Attn: Guadalupe River Bridge Comments

I participated in the Dec. 10, 2020, tele-conference presentation and discussion of Caltrain's plans for replacing and extending the Guadalupe River bridges. I asked some questions then, and am writing now to go into further detail and to formally submit my comments and questions.

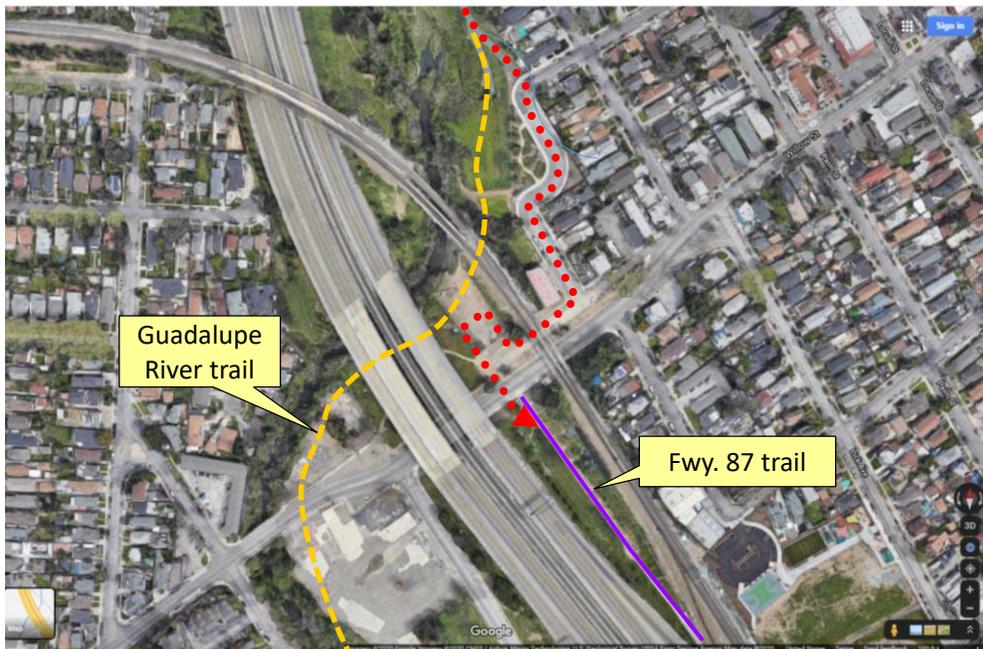
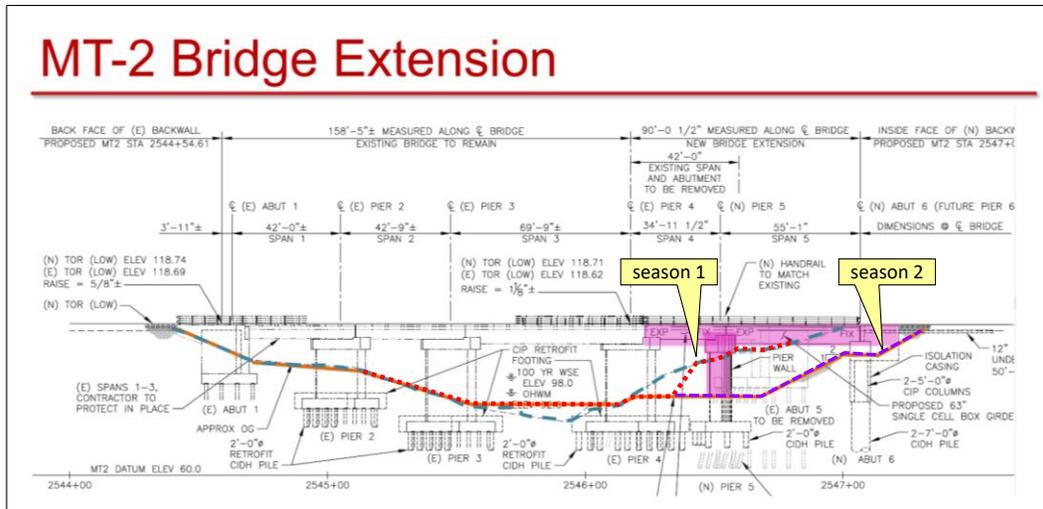
My main concern relates to minimizing environmental impacts to the Guadalupe River. From all the discussions around Caltrain electrification and the resulting anticipated increased service in this area, plus HSR coming to Diridon and the reconfiguring of Diridon Station: all these plans call for at least three tracks in this reach: one for freight, one for northbound passengers, and a third track for southbound passengers. Your plans call for dewatering the river one season to replace the older bridge (MT-1), and then dewatering the river a second season to extend the other bridge (MT-2), leaving it to you or some other agency to have to dewater the river a third season to construct the needed third bridge (#3). So my question: is there a way to minimize these impacts to the Guadalupe River?

One alternative: why not replace MT-1 with a double track bridge? I appreciate that the plan here is to extend MT-2 rather than replace it, and thus it is not practical to add a second track to that bridge, but MT-1 is a completely new bridge which readily could be made wider. Double the tracks on MT-1 now when there's the opportunity, and then the river will not need to be dewatered for a third season in order to construct the needed third bridge, and thus environmental damage can be reduced.

And is it even necessary to dewater the river for two seasons? Could the in-channel grading for MT-2 be done while the river is dewatered for the construction of MT-1, without disrupting train service on MT-2, as shown by the dotted red line below? Then, during the second season when MT-2 is being extended, all of the remaining grading (purple dashed line) would be outside of the river channel and thus wouldn't require a second river dewatering.

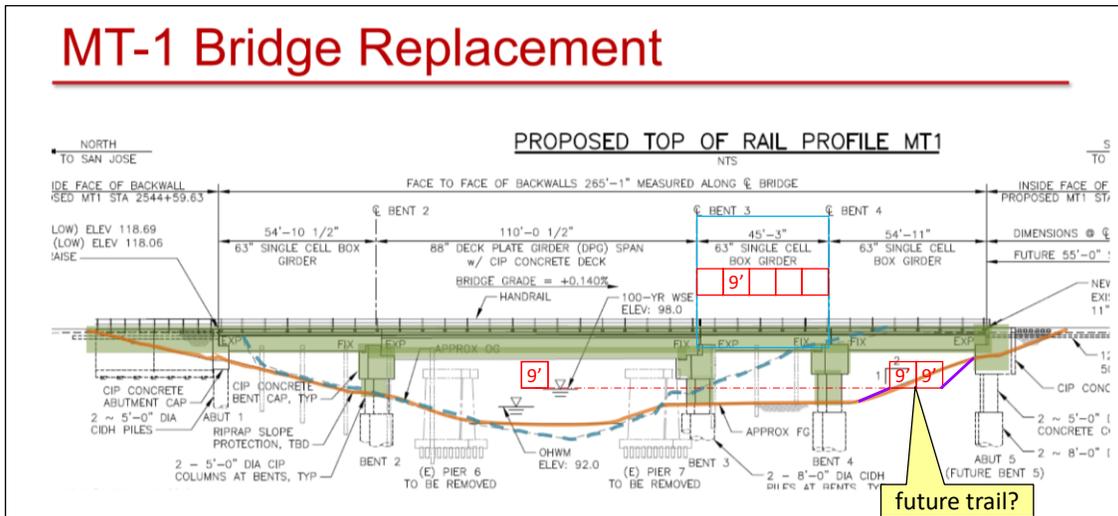
Utilizing an analytical technique from my aerospace past, it appears to me that it would be quite feasible to grade a "bench" between Bents 4 and 5 on MT-1 that is outside even the channel of a 100-year flow and still have in excess of 9' vertical clearance. (Analysis method: the blue box in the diagram matches

the feature that is dimensioned as 45'3"; scale it by 20% to get a 9' box, and copy that box onto the 100-Yr WSE ("water surface elevation") mark to check vertical clearance. Of course, a more thorough analysis is needed to verify and refine these PowerPoint studies.)

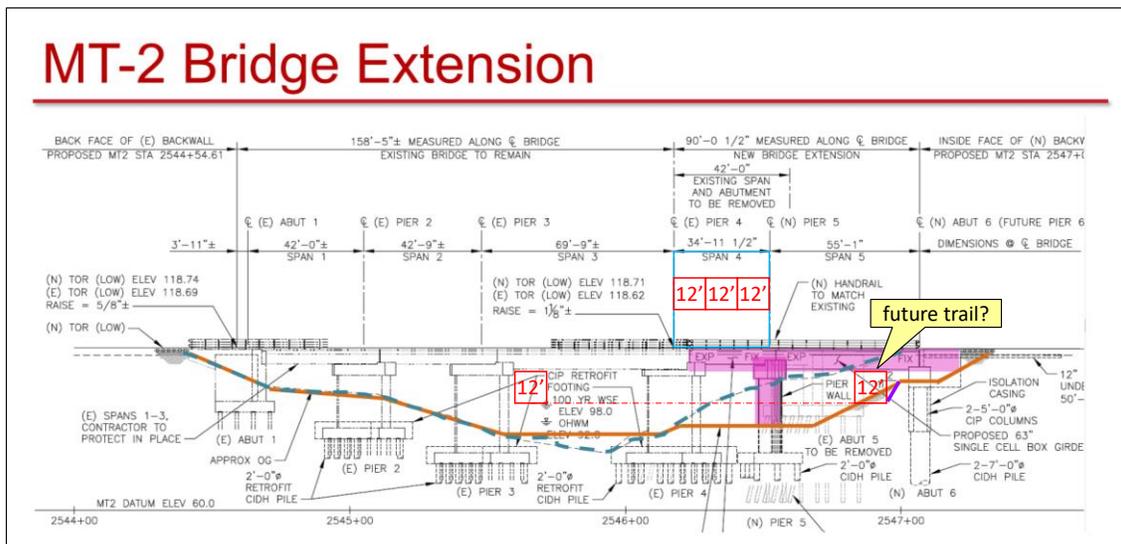
For the extension of MT-2, it looks like it would be possible to have nearly 12' of vertical clearance outside the 100-year flood zone, passing between Pier 5 and Abutment 6.

It would appear to require a trivial amount of grading to go from the "approx. FG" ("future grade", in the orange-brown line) to what I'm proposing (the purple line by the red box). If this possible future trail alignment is not precluded by the Caltrain construction, then trail advocates in the community can discuss further details with Valley Water as they design their next projects in this reach.
